Notice of Allowability

09/664,096

EXAMINER'S AMENDMENT

FIG. 16

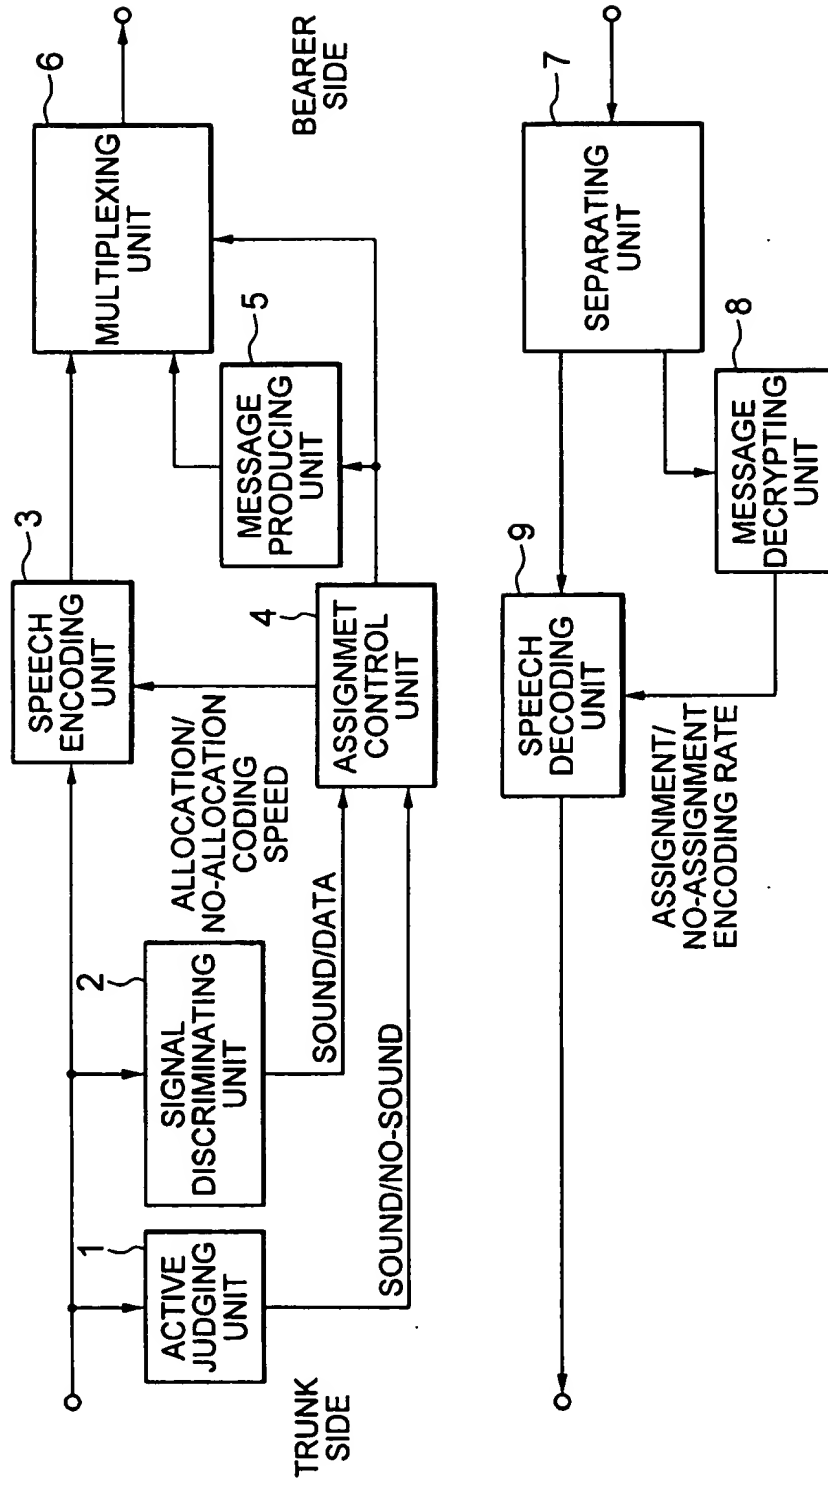
- In the **drawings** (in accordance with MPEP § 608.02(g)), **Figure 16,18, and 19** have be designated by a legend such as -- **Conventional Art** -- (see attached).
